**Grimes Planning and Zoning Commission
March 4, 2025 @ 5:30 PM
Grimes Community Complex, 410 SE Main Street**

RE: Merkle Retirement Planning Site Plan Amendment

PLAT & CONSTRUCTION PLANS
FOR
MERKLE FINANCIAL BUILDING ADDITION
1860 SE PRINCETON DRIVE
CITY OF GRIMES, POLK COUNTY, IOWA

RE: TMJ Roofing Building Addition Site Plan Amendment

V:\Projects\2024\124.1489\124.1489-0000.DWG: 124.1489 - DIM. AND UTILITY PLAN, 2024/02/27, 2:34 PM, ANS FULL BLEED, 0.34 X 22.00, 22.00 INCHES

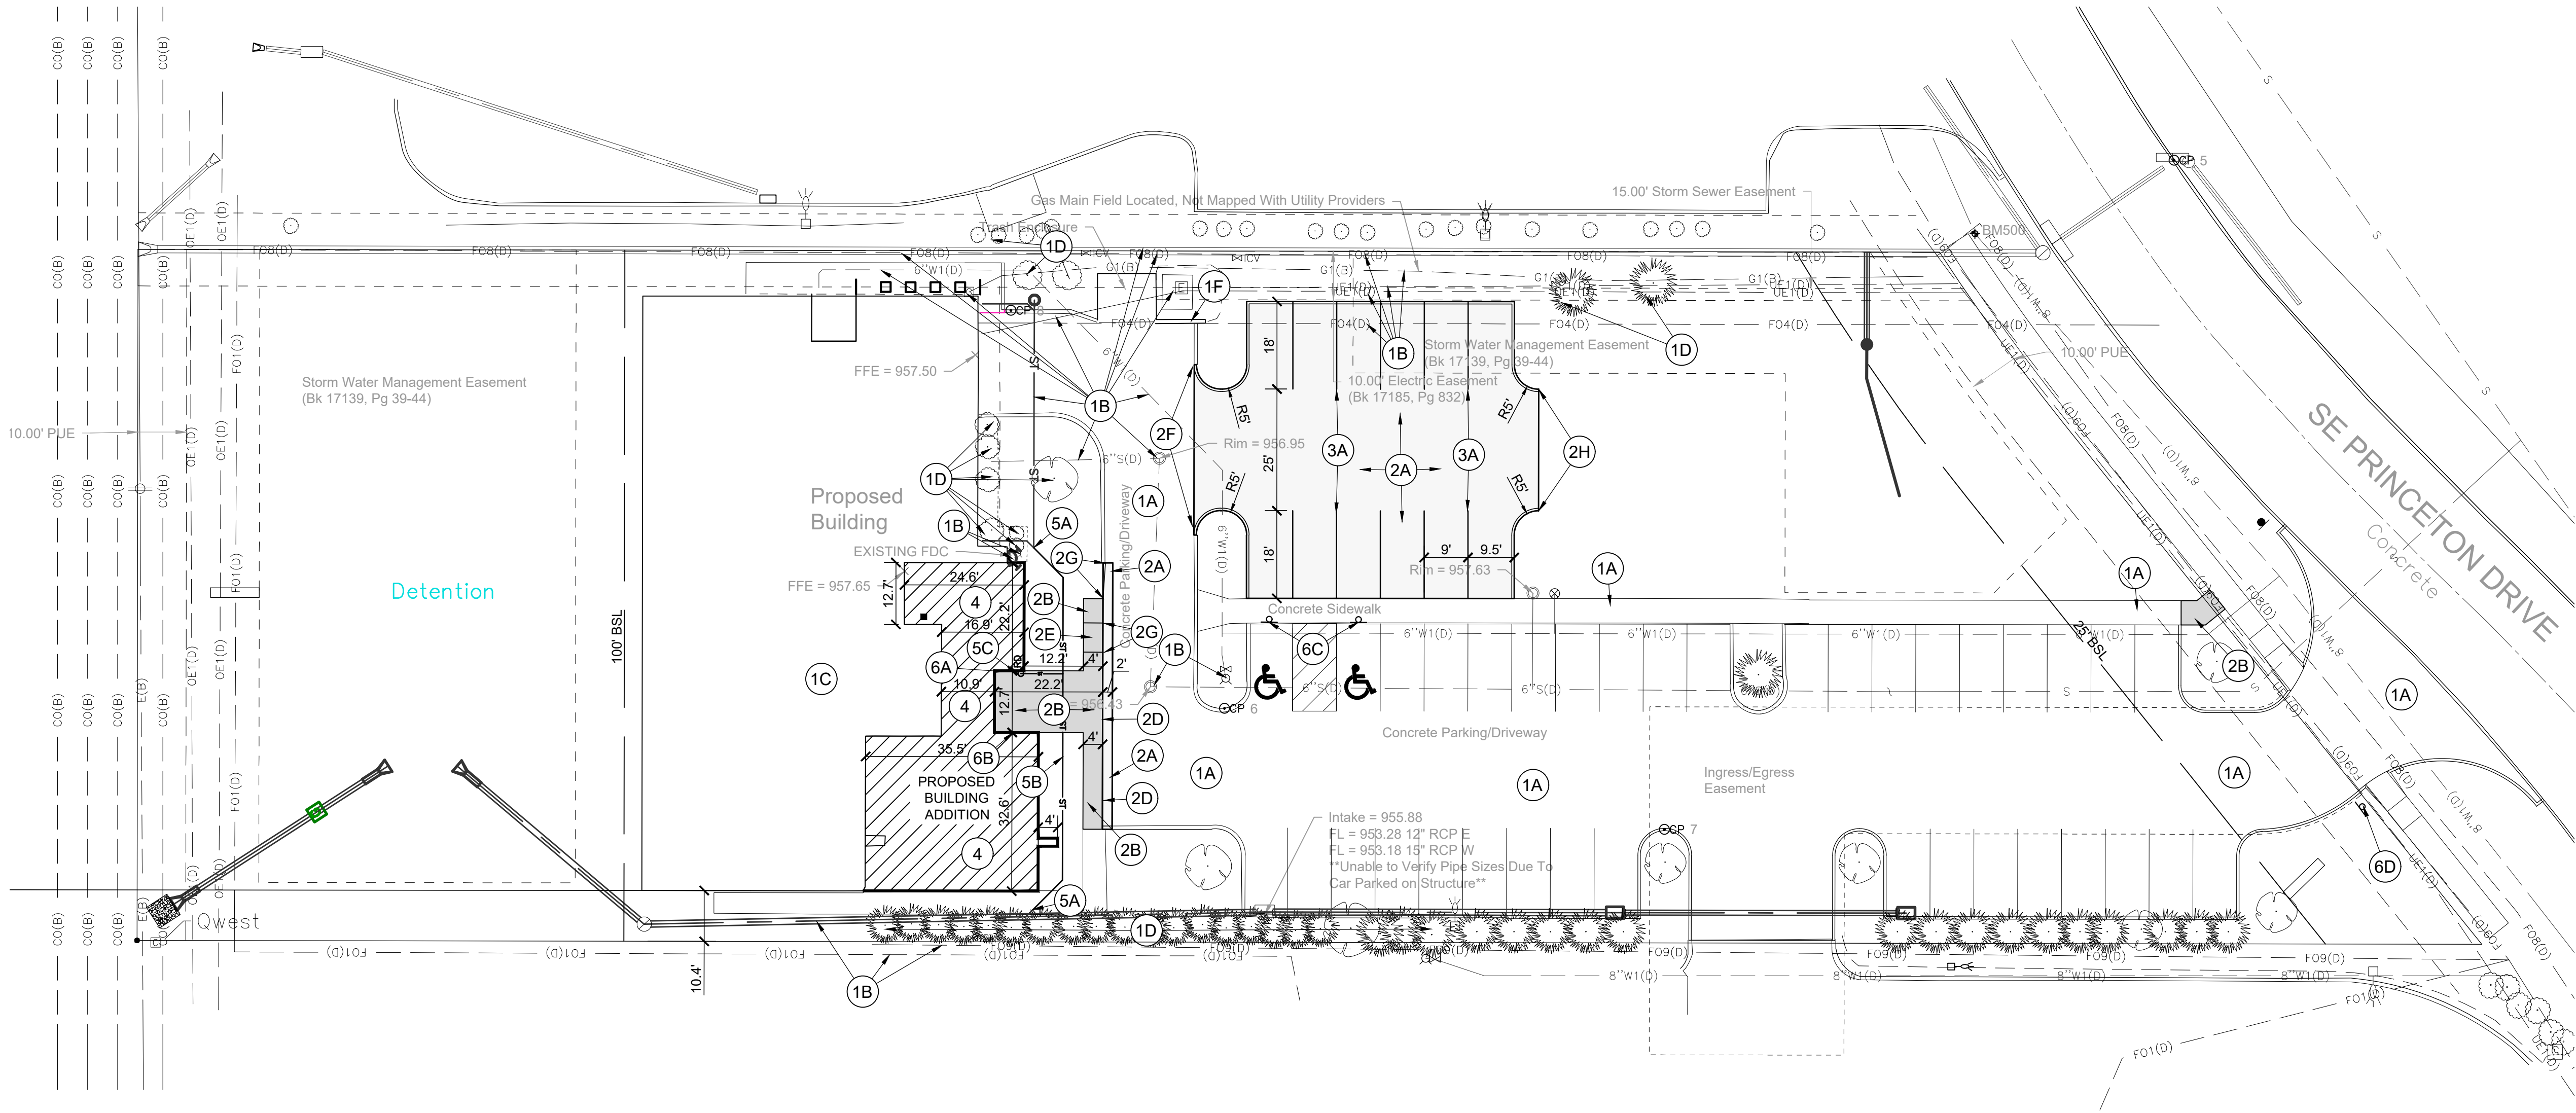
Sheet C300:

- ~~1. Provide utility quantities table.~~
- ~~2. Show how the roof drains will tie to the storm sewer. There are notes for #5 A-C but no labels on the plan.~~
- ~~3. Please identify the location of the Fire Department Connection and the location of the hydrant that is required to be within 100' of the FDC.~~
- ~~4. Please label the setbacks of the addition. Depending on the proximity to the property line, there may be limitations on percentage of glazing in the south exterior wall. Please label the setback of the building to the south property line.~~
- ~~5. Suggest connecting the sidewalk along the existing north row of parking to the public sidewalk along SE Princeton Dr.~~
- ~~6. Suggest adding a stop sign out to the public street.~~

PLANTING PLAN

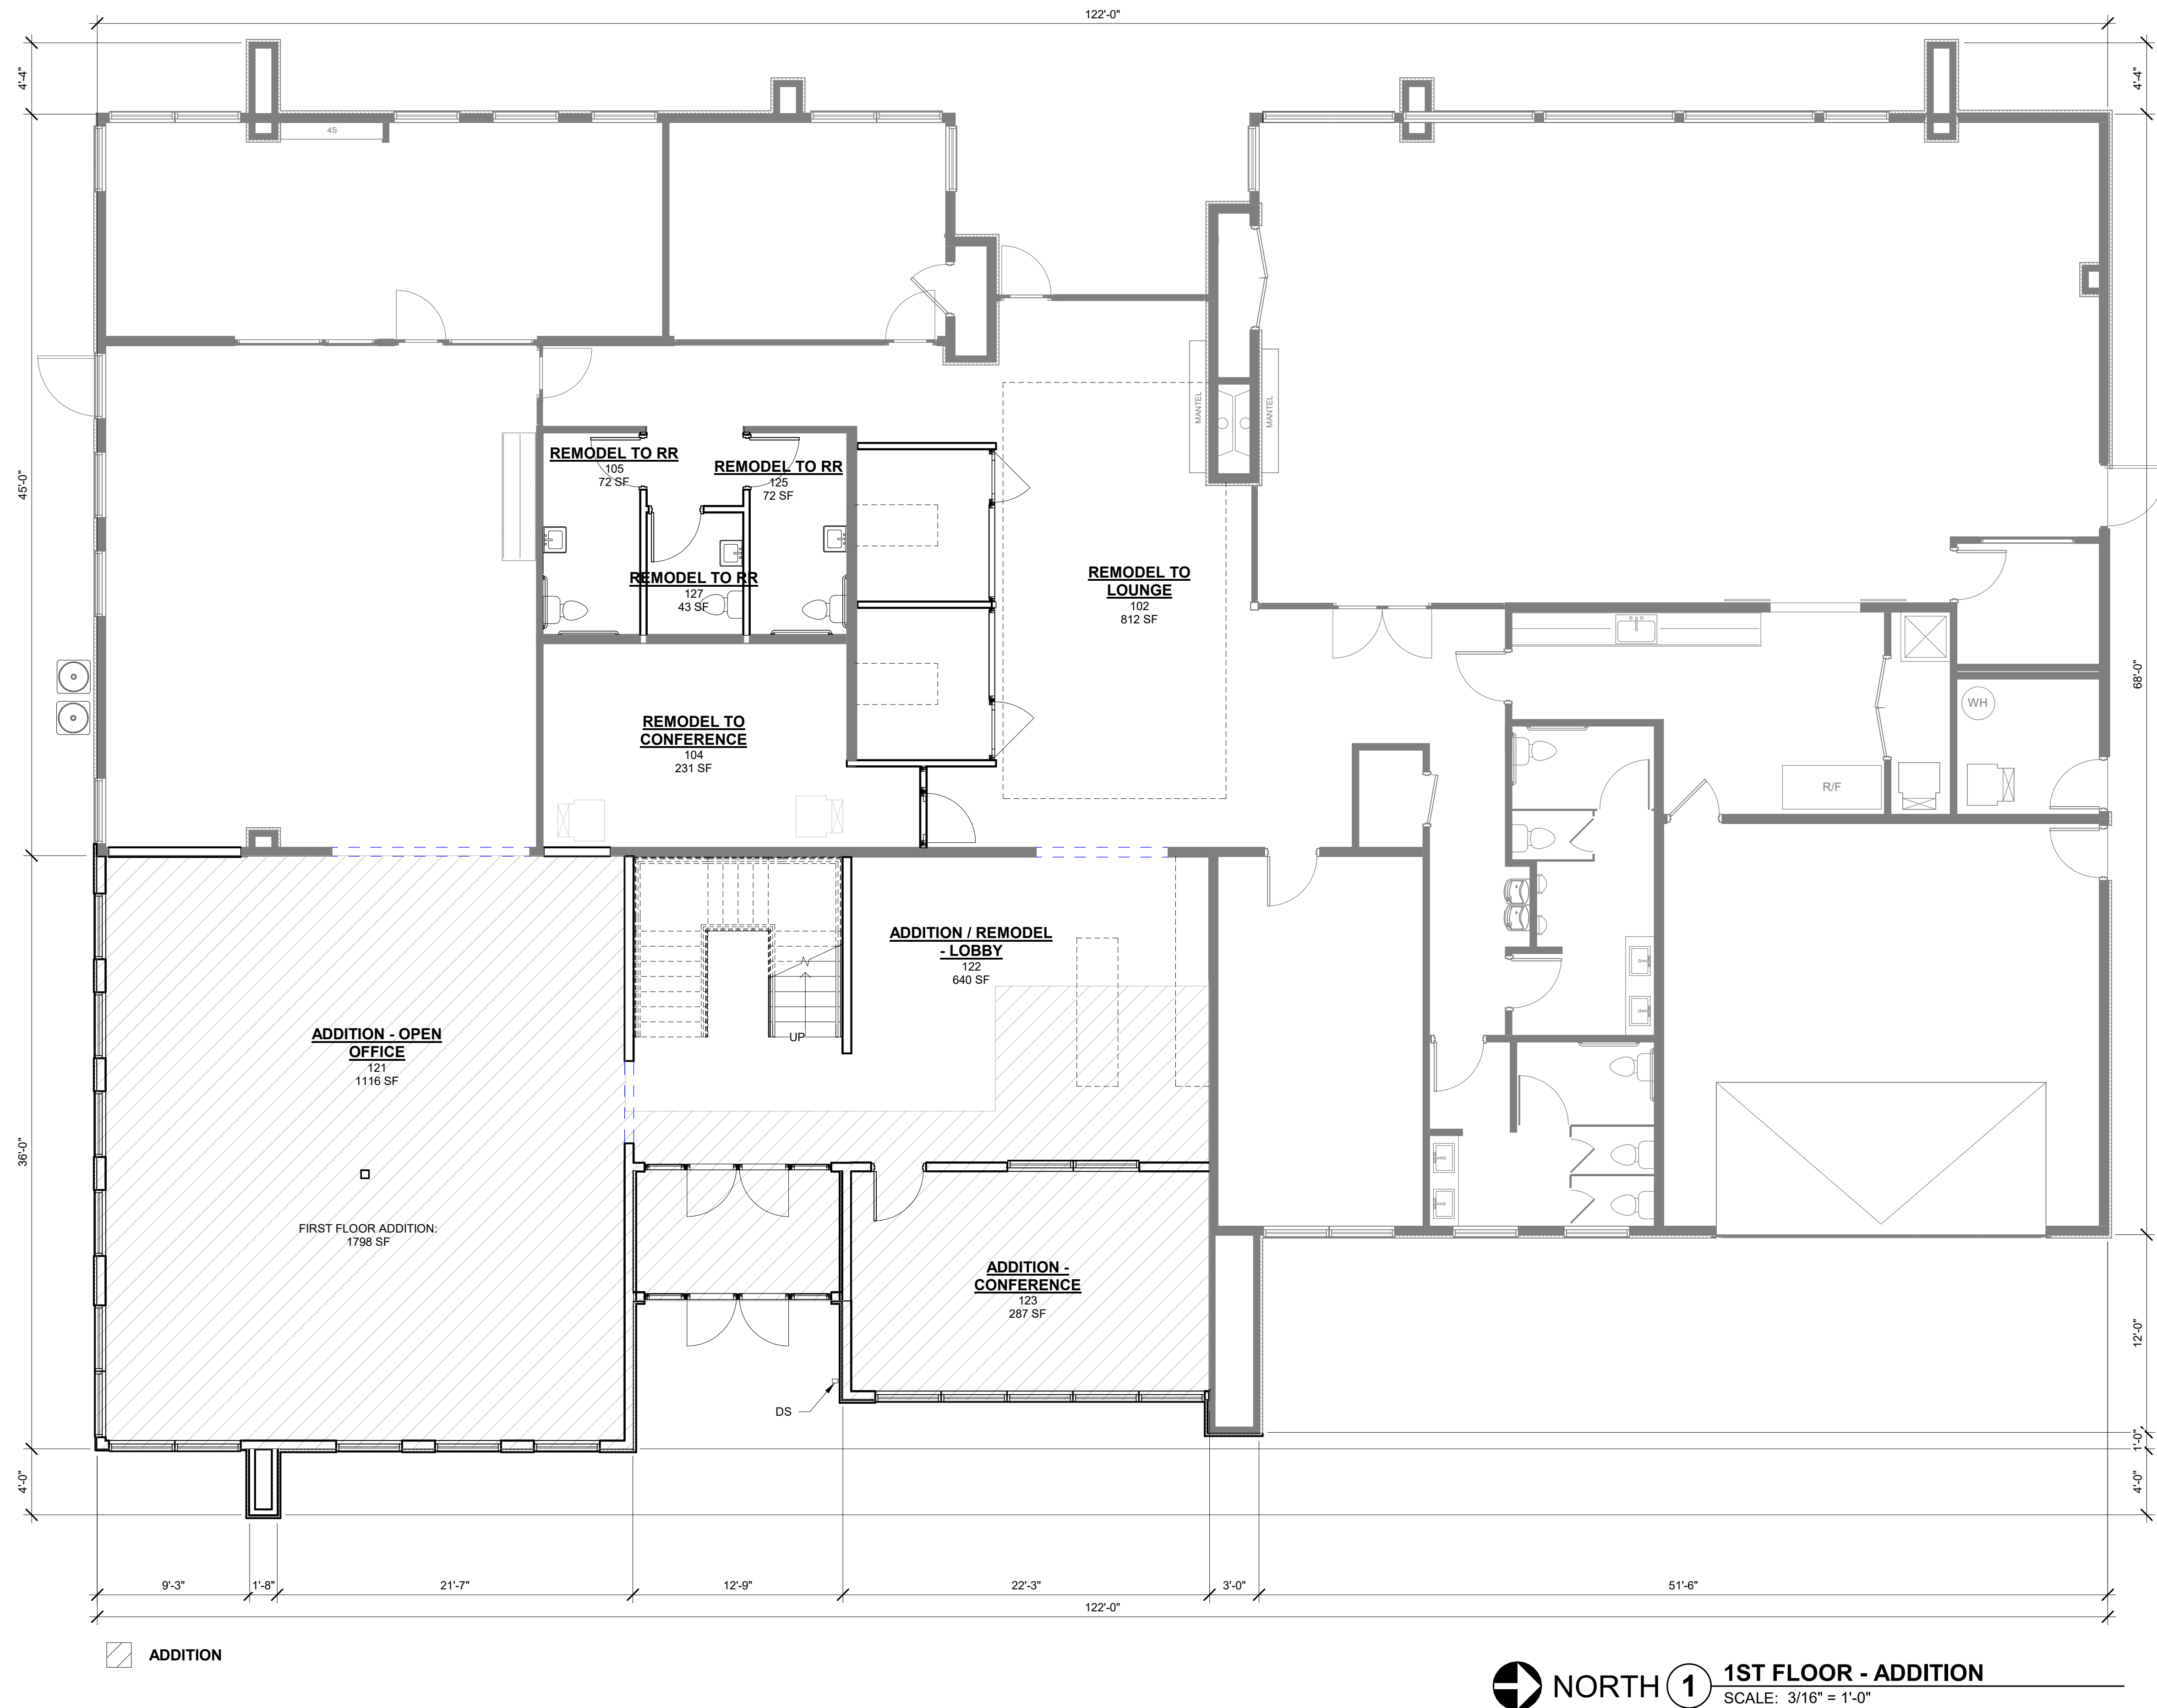
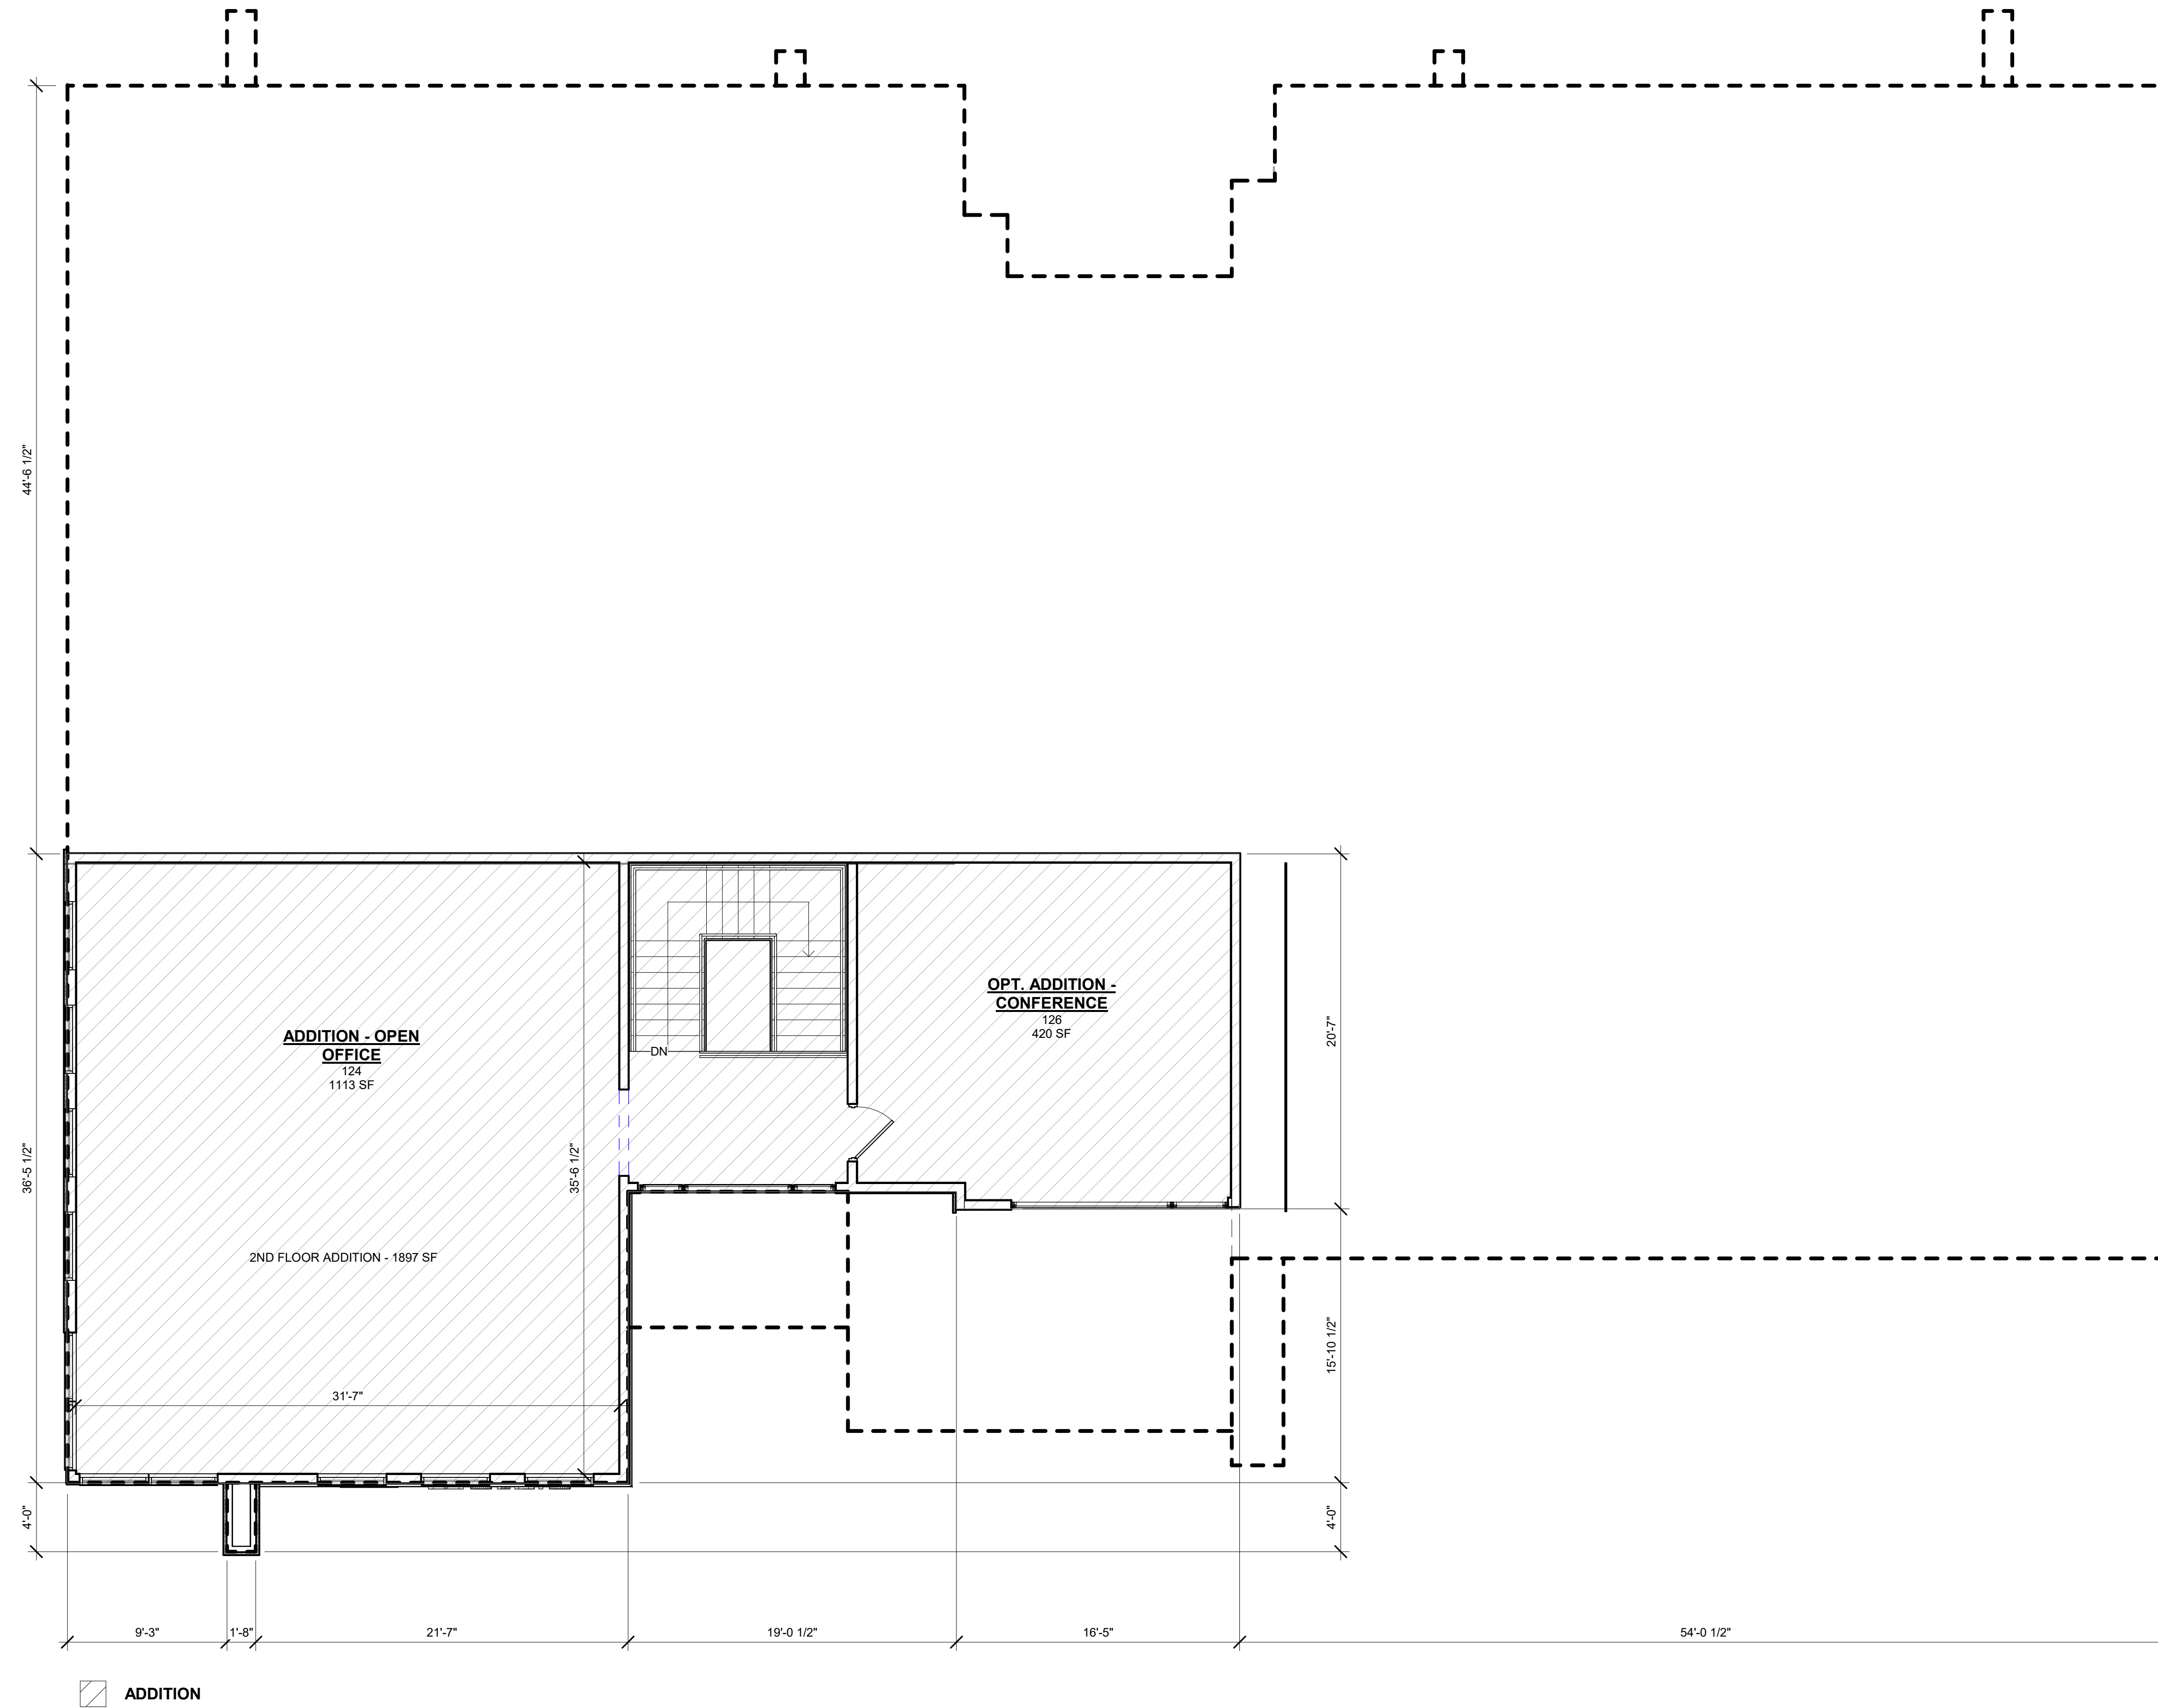
1. ~~Some trees are missing from the original site plan. Please show the installation of the missing trees.~~
2. ~~Update open space calculation to 20% minimum open space and update the required plantings.~~

2 TREES PER 1,000 SF OF MINIMUM OPEN SPACE
6,028.7 / 1,000 SF = 6.03 PLANT UNITS
6.03 P.U. X 2 = 12.06 TREES REQUIRED (21 EXISTING TREES
PROVIDED DURING PHASE 1, 4 TREES PROVIDED)

1 SHRUB PER 500 SF OF MINIMUM OPEN SPACE
6,028.7 / 500 = 12.06 PLANT UNITS
12.06 P.U. X 1 = 12.06 SHRUBS REQUIRED (6 EXISTING SHRUBS
PROVIDED DURING PHASE 1, 7 SHRUBS AND 13 GRASSES
PROVIDED)
